Access Compliance Report Public Rights-of-Way (Curb Ramps)

Intersection ID: 23329 Main Street: GLENEAGLES RD Cross Street: PARK_RD Location: NE

ADA ID: B20B7F3282FB Ramp Type: PerpDiag Initial Pass/Fail: Fail **Overall Compliance: No** Severity Score: 33.75

# 1

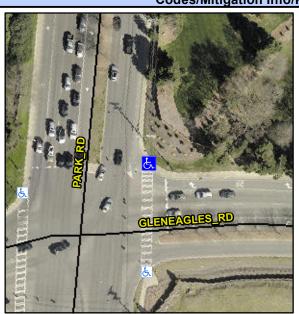
Field Measurements/Component Compliance						
	Compliance Description		Data	Comp	oliance Description	Data
ı	N/A	Ramp Length (in)	58.0	No	Ramp Slope (%)	12.2
ı	No	Ramp Width (in)	36.0	Yes	Ramp XSlope (%)	0.4
ı	N/A	Flare Type LT	N/A	N/A	Flare Type RT	N/A
ı	N/A	Flare Slope LT (%)	N/A	N/A	Flare Slope RT (%)	N/A
ı	N/A	Flare Traversable LT?	N/A	N/A	Flare Traversable RT?	N/A
ı	N/A	Landing Length (in)	N/A	N/A	DWS Provided?	N/A
ı	N/A	Landing Width (in)	N/A	N/A	DWS Contrast?	N/A
ı	N/A	Landing Slope (%)	N/A	N/A	DWS Length (in)	N/A
ı	N/A	Landing X Slope (%)	N/A	N/A	DWS Full Width?	N/A
ı	N/A	Landing Curb? (Y/N)	N/A	N/A	DWS Offset (in)	N/A
ı	N/A	Shared Landing?	N/A			
ı	N/A	Gutter Ponding?	N/A	N/A	Gutter Slope (%)	N/A
ı	N/A	Gutter Lip Ht (in)	N/A	N/A	Gutter X Slope (%)	N/A
ı	N/A	Painted X Walk1?	No	N/A	Painted X Walk2?	Yes
		X Walk 1 Direction	To SW		X Walk 2 Direction	To S
ı	N/A	X Walk 1 Width (in)	N/A	N/A	X Walk 2 Width (in)	123.0

X Walk 1 Slope (%)	3.3		X Walk 2 Slope (%)	2.0
		X Walk 1 X Slope (%)	0.6		X Walk 2 X Slope (%)	1.9
ı	N/A	Ramp inside XWalk1?	N/A	N/A	Ramp inside XWalk2?	Yes
		Road Slope (%)	2.8	N/A	Clear Space?	N/A
		Road X Slope (%)	0.7	N/A	Clear Space to XWalk (in)	N/A
	N/A	Any Obstructions?	N/A	N/A	Storm Grate/Utility Hazard?	N/A
		Obstruction Type			Storm Grate/Utility Type	
			N/A			N/A
				Yes	Surface Condition? (G/P)	Good

Possible Solutions: Remove & Replace Curb Ramp With **Two New Directional Ramps or** Equivalent. Surveyor Notes: N/A PROW/ADA: R304.5.1, R304.2.2
